Subject: Responses to Cygna Design Control, Pipe Support, and Pipe Stress
Questions
Comanche Peak Steam Electric Station
Independent Assessment Program - Phase 3
Texas Utilities Generating Company
Job No. 84042

COMANCHE PEAK STEAM ELECTRIC STATION
CPSES CYGNA REVIEW QUESTIONS
(PIPE SUPPORTS)

TEXAS UTILITIES GENERATING COMPANY
COMANCHE PEAK STEAM ELECTRIC STATION
G&H PROJECT NO. 2323
ADDITIONAL RESPONSE TO CYGNA LTR 84042.007 DTD 6/23/84
REF: GTN-69190 DATED JUNE 29, 1984

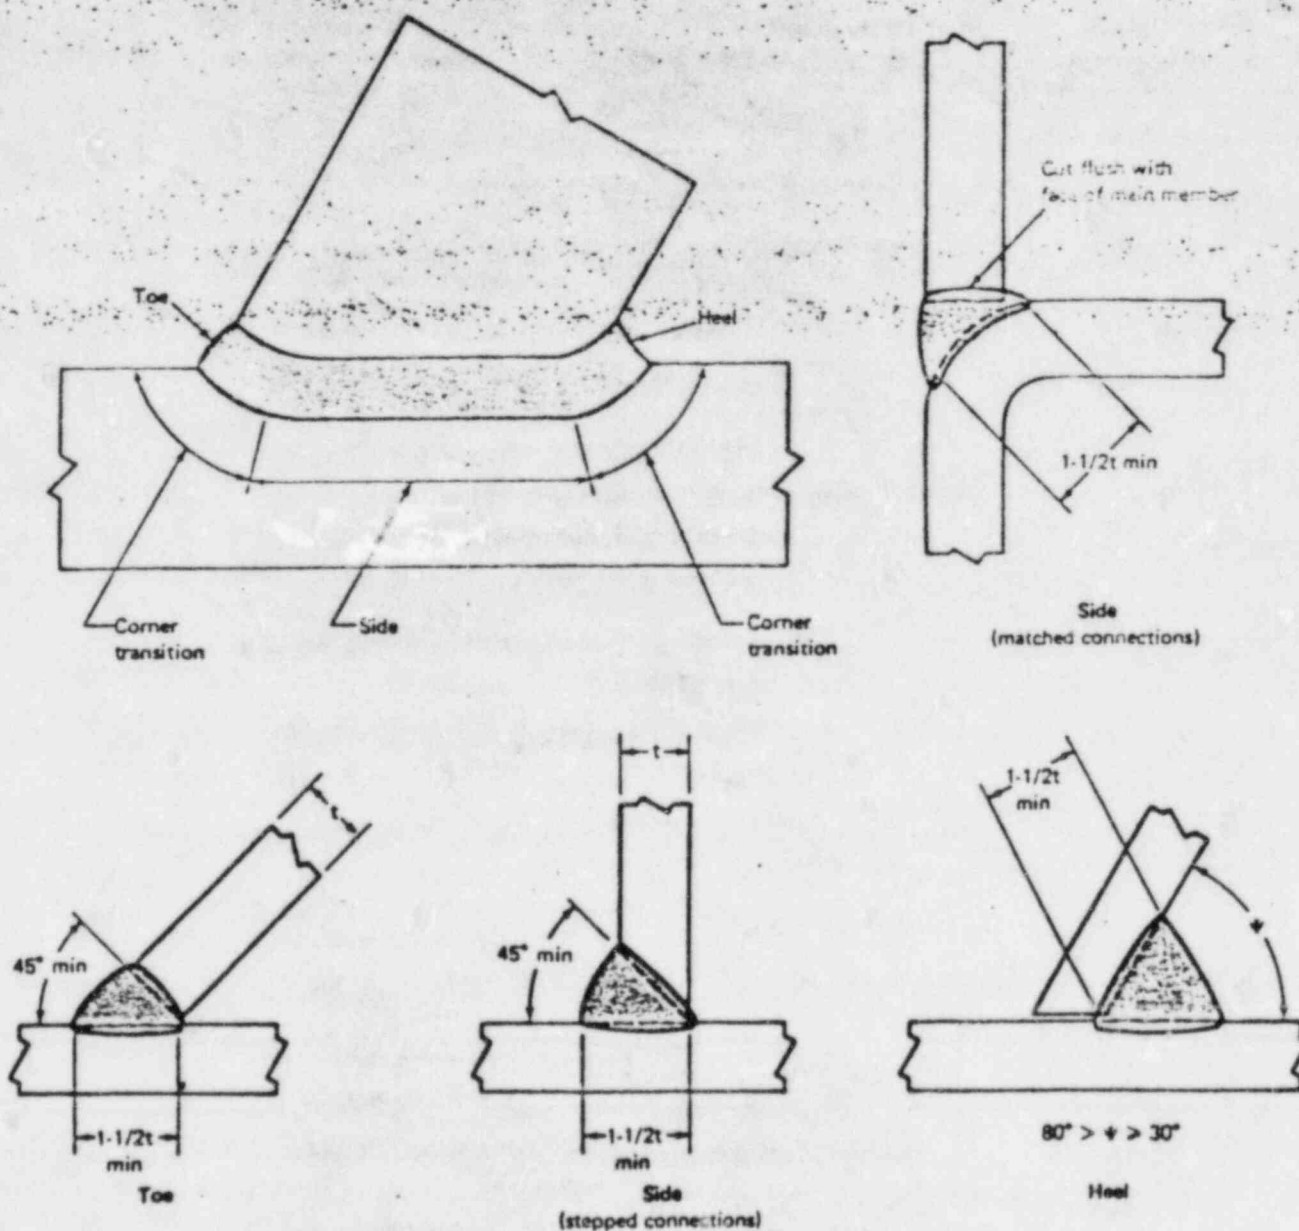
- It is our interpretation of existing weld standards that the effective throat of a flare bevel weld (t_e) is $5/16R$. Assuming $R=2t$, then $t_e=5/8t$. What justification does TUGCO have for using $t_e=t$ in flare bevel weld design?
- Please provide documentation which instructs engineers how to calculate the effective throat of a flare bevel weld with a fillet cap.

- Per AWS D1.1, 1979 edition, figure 10.13.1.3B, an effective throat of t is specified (see attached). Based on the geometry of the joint, $t_e=t$ is a reasonable value.*
- Calculation of weld effective throat (in any joint) is based on the shortest distance from the root of the weld to the face of the weld. For a flare bevel with a fillet cap, the engineer uses this approach in calculating t_e . The example supplied to CYGNA for MS-1-003-013-C72K, shows this calculation is done.

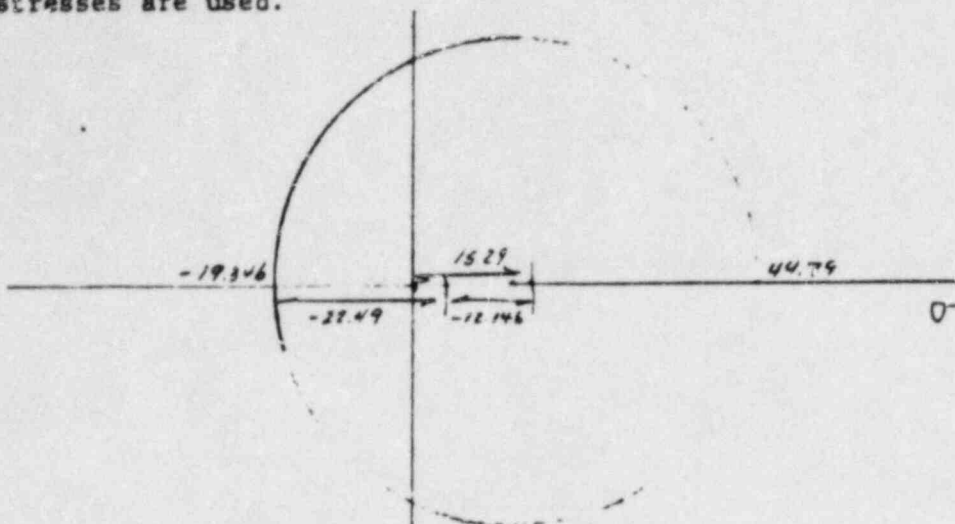
1. Please provide a detailed numerical breakdown of how the stresses in Tables H, I, N and O of the Affidavit (reference 3) were obtained. The easiest way to show how the stress intensity is obtained is to refer to the figure VII-2 of Attachment 3 of the Affidavit which defines it as the maximum of either the absolute difference between the major principal stress or minor principal stress and zero, or the algebraic difference of the two principal stresses, and to apply this figure to an actual example. The example chosen is the 4" sch 160 pipe. For the elements having the largest circumferential and longitudinal stresses, the finite element analyses determined that the principal stresses are virtually identical to the circumferential and longitudinal stresses (see Attachment 3 of Affidavit at page 57). The longitudinal, circumferential, major and minor principal stresses for the highest stressed piping element of the 4" sch 160 pipe are given for both the inside and outside surfaces and for the maximum load case in the table of p. 58 of Attachment 3 to the Affidavit. These values are reported below:

To add the piping moment stresses to the longitudinal (minor principal) stresses, we choose the sign which will produce the largest stress intensity.

This is seen in a Mohr circle depicted below, where inside surface stresses are used.

Thus the total stress intensity is given by $44.79 - (-19.346) = 64.136$ ksi, which is the total stress intensity given on page 59 of Attachment 3 of the Affidavit or in table H of page 60 of the Affidavit.
